City of Chicago Section 106 Review – Historic Property Identification and Determination Checklist
HUD Funded Program Subject to Section 106 Review: Multi-Family Loan Program
Subject Property Address: 2120-28 N. Mozart St. – Humboldt Park United Methodist Church Redevelopment

PART A: Determination of Area of Potential Effects (APE)

SHEET ID
A-111
FLOOR PLANS - GARDEN/GRADE AND LEVEL 01

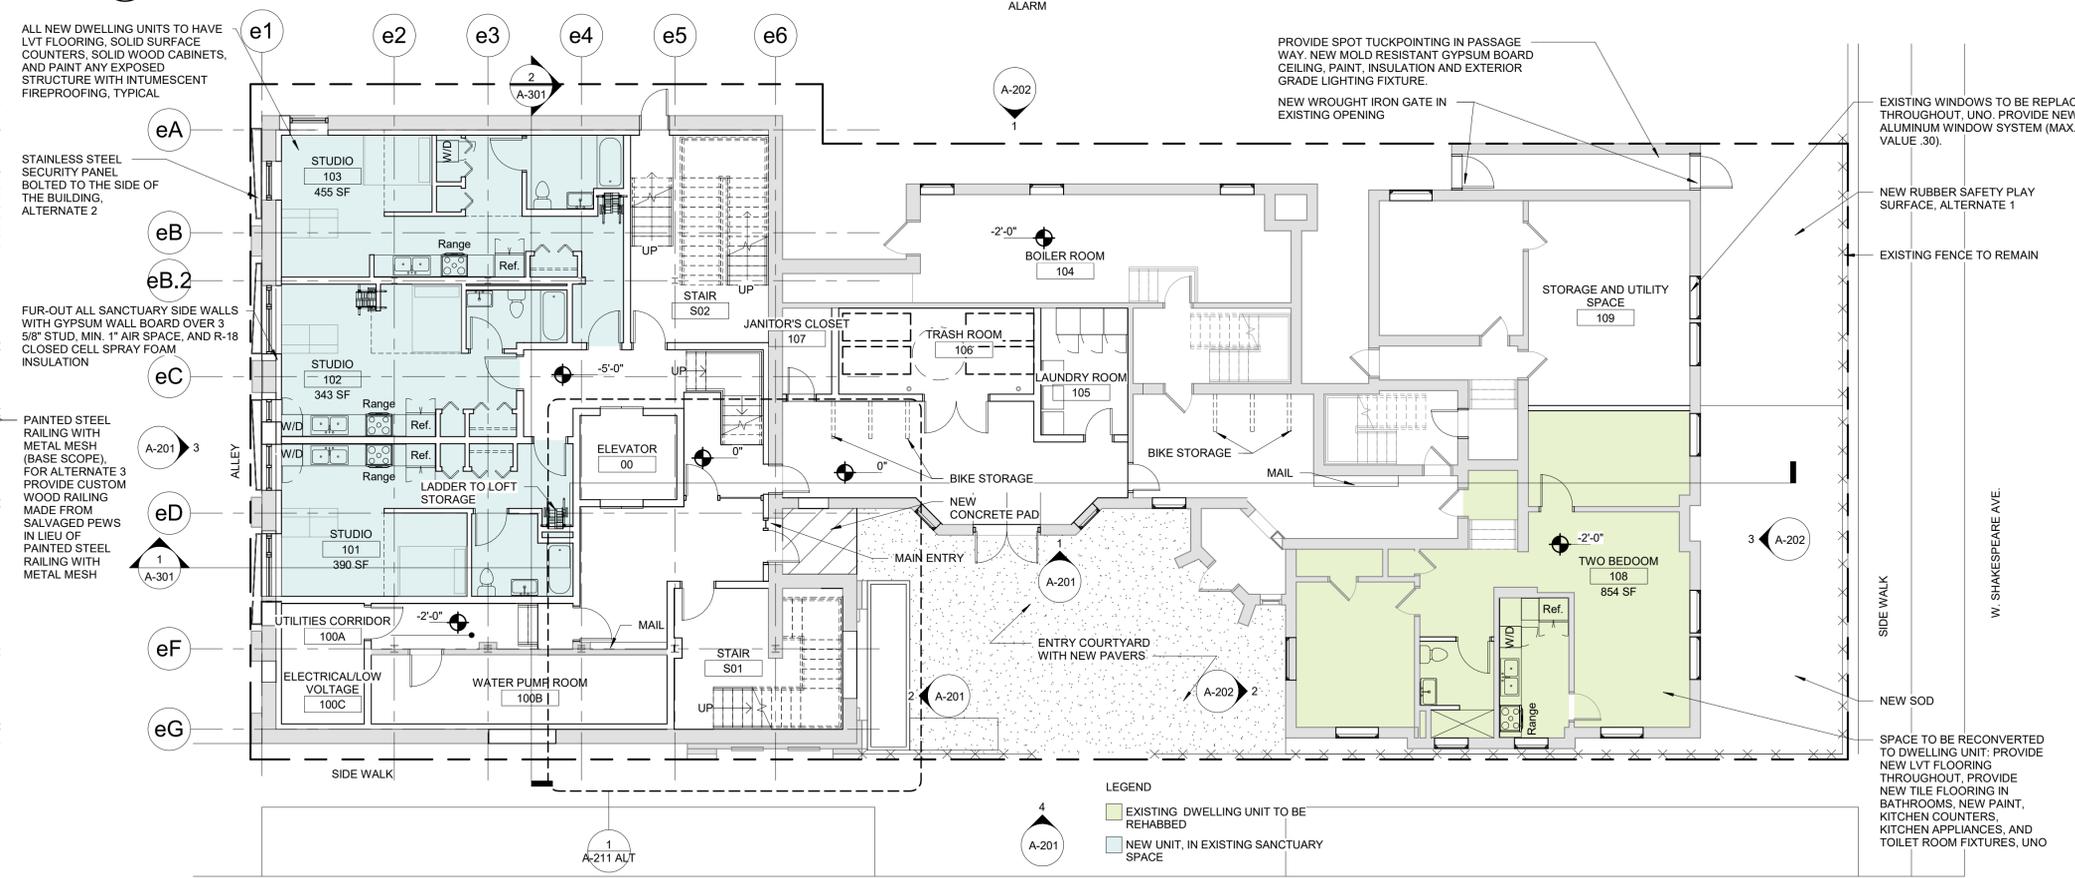
At the interior, the proposed rehabilitation to existing dwelling units including electrical, plumbing, and HVAC upgrades are considered exempt activities as described above in Part E. The proposed modifications to the existing sanctuary space, including removal of existing balcony, stairs, and pipe organ, as well as construction of new walls, floors, stairs, and elevator dividing the currently open volume, would diminish the historic property's integrity of design, materials, and workmanship such that it's potential eligibility for listing in the NRHP under Criterion C would be compromised.
